## Cellular Tower at M-5 and Twelve Mile Road SP 08-40D

### CELLULAR TOWER AT M-5 AND TWELVE MILE ROAD, SITE PLAN 08-40D

### Planning Review

Revised Preliminary Site Plan and Special Land Use Permit

# VERIZON'S CURRENT COVERAGE AS OF MARCH 2010

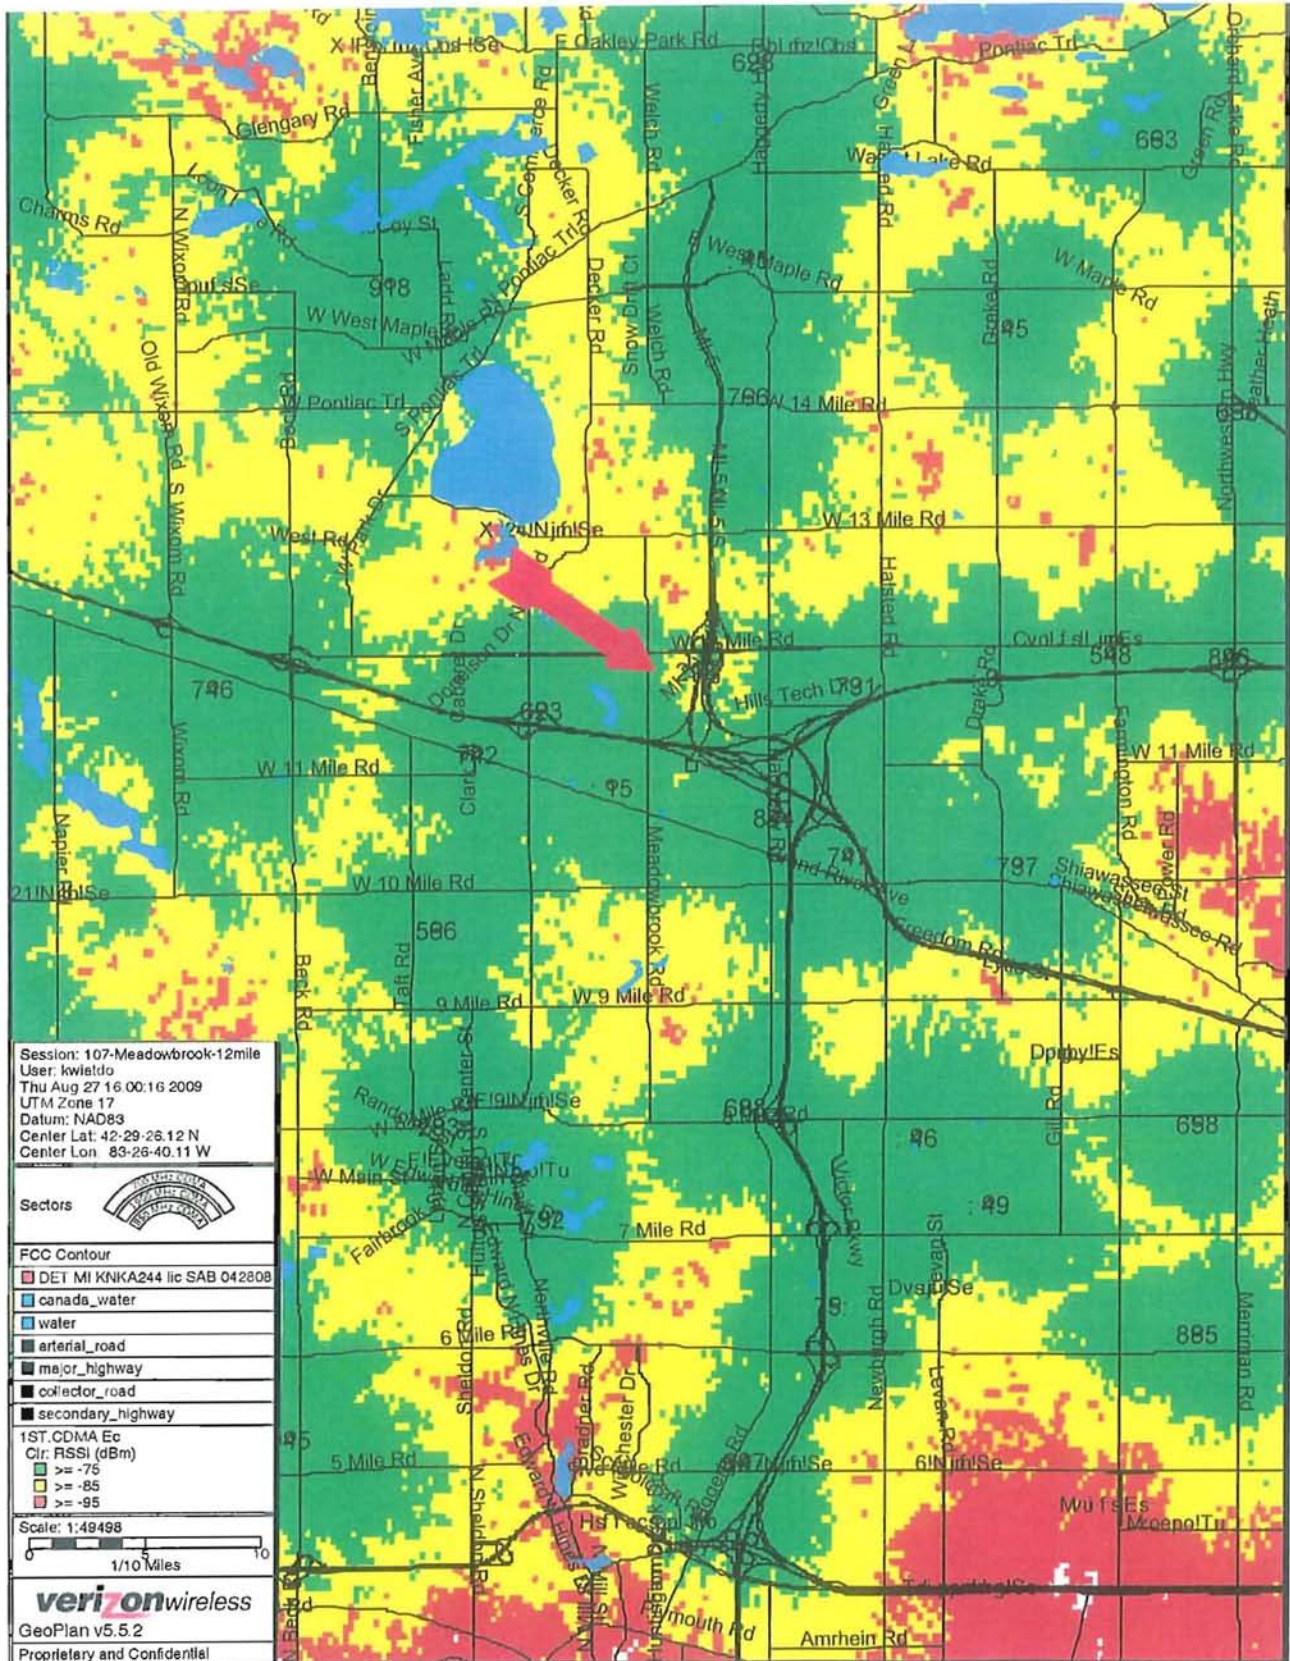
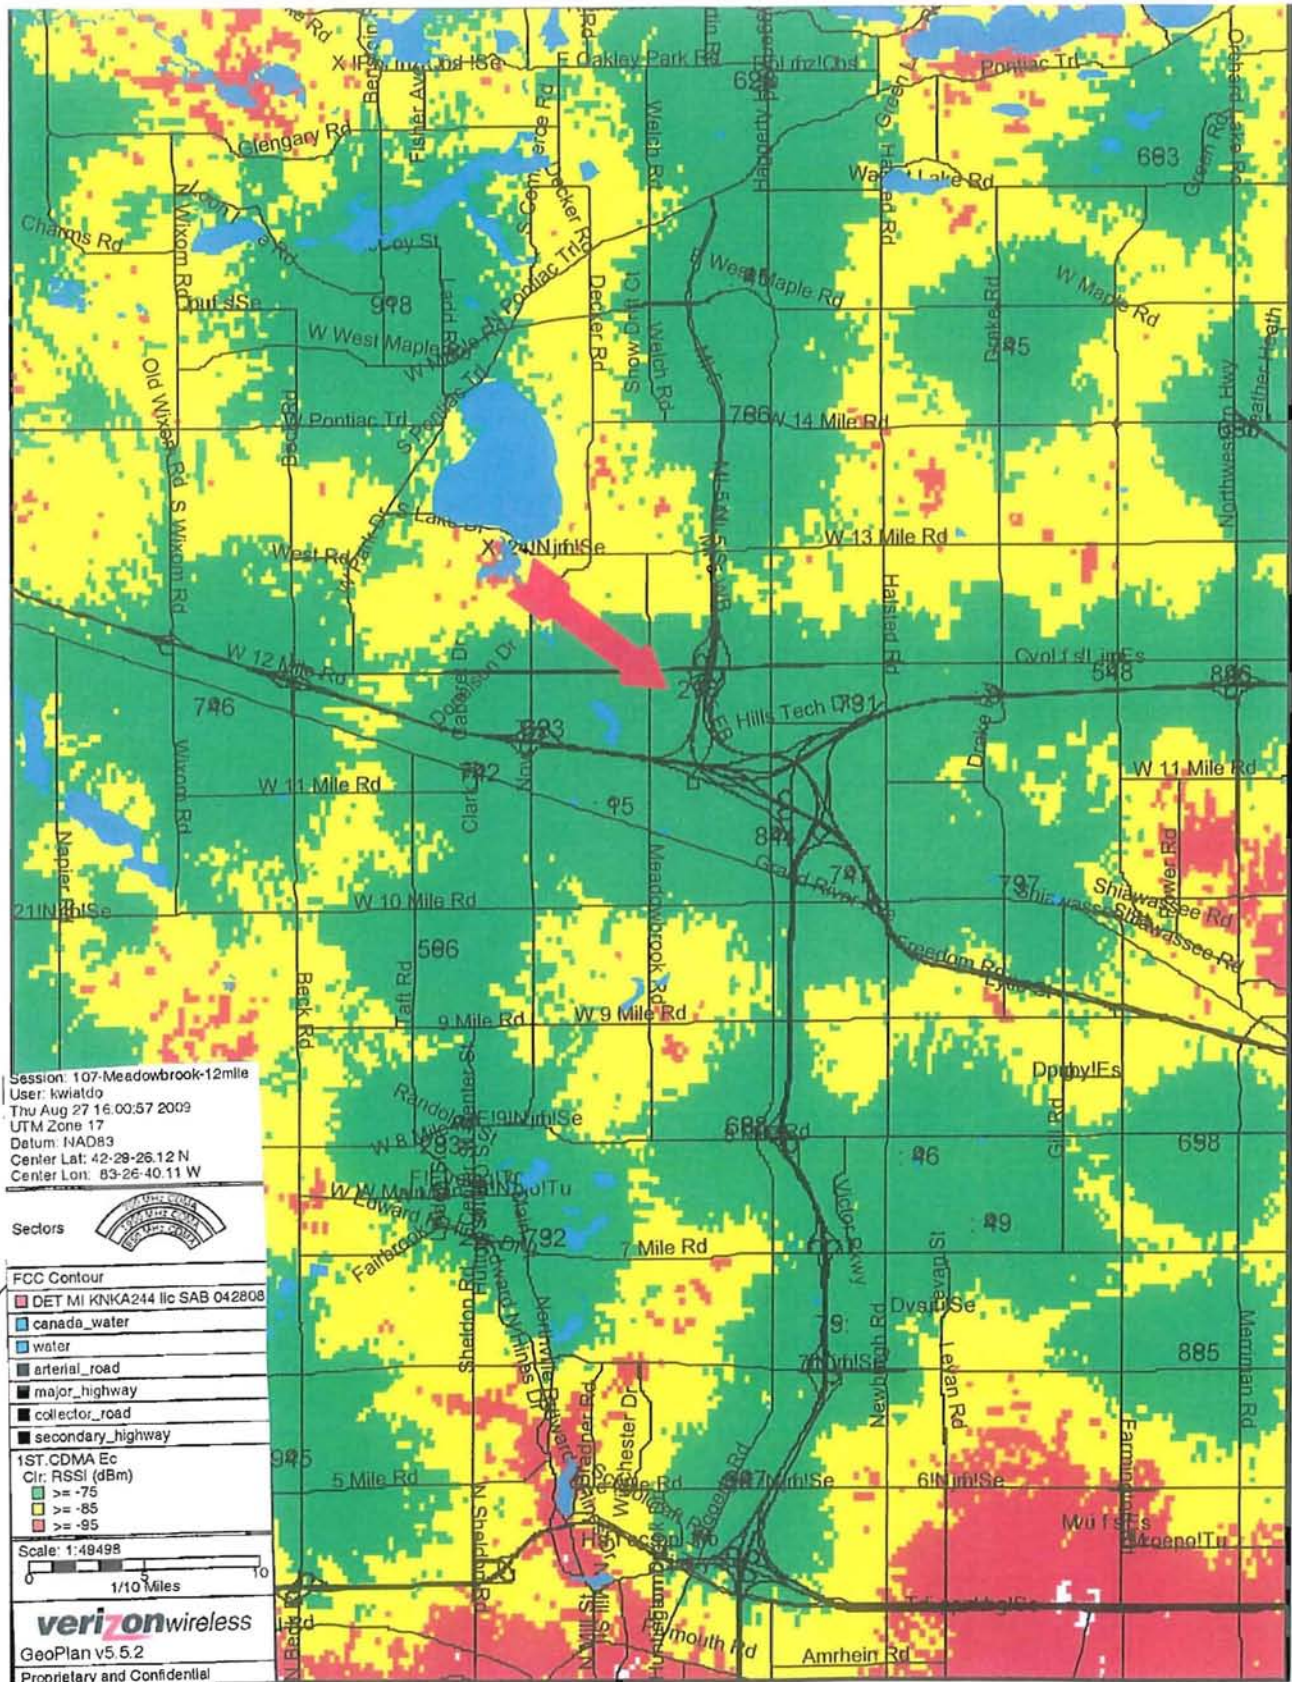
The applicant provided completed SBA applications from T-Mobile and Verizon to locate on the proposed tower. The applicant has provided an "indoor coverage" propagation map for T-Mobile demonstrating existing and expanded indoor coverage with a facility on the proposed tower and existing and proposed propagation maps for Verizon showing an increase in RSSI (dBm) demonstrating expanded coverage with a facility on the proposed tower. The applicant has stated that the maps show an increase in "green" areas that demonstrate best coverage areas. Technical details explaining the maps was not provided.
